Product Change Notification

PCN No: PCN-2013-08-01

Change Title: GDS 307 contact holder

Affected Product(s): GDS 307 black
GDS 307 grey.

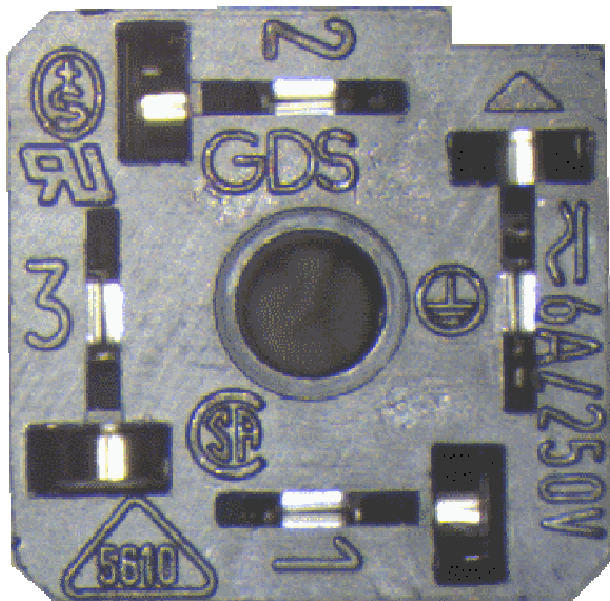
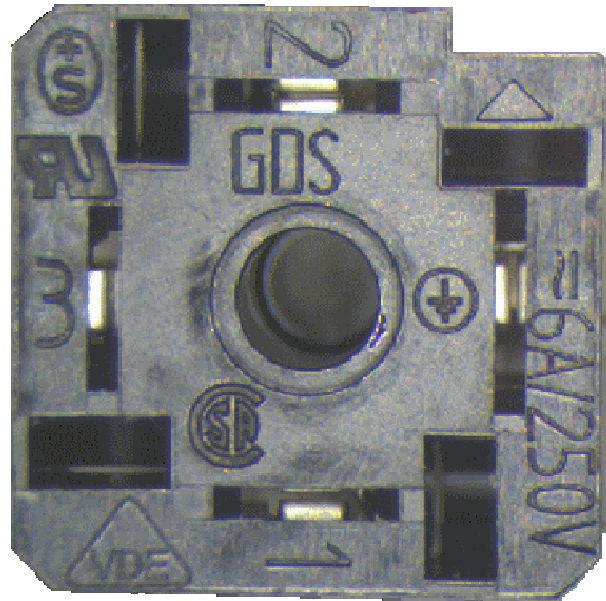
Slight modification of contact holder design.

The old molding tool is worn out and has to be replaced. New tool is slightly different due to new approval (VDE logo) and tool design requirements.

Form: slightly modified
Fit: not affected
Function: not affected
Reliability: not affected
Others: not affected
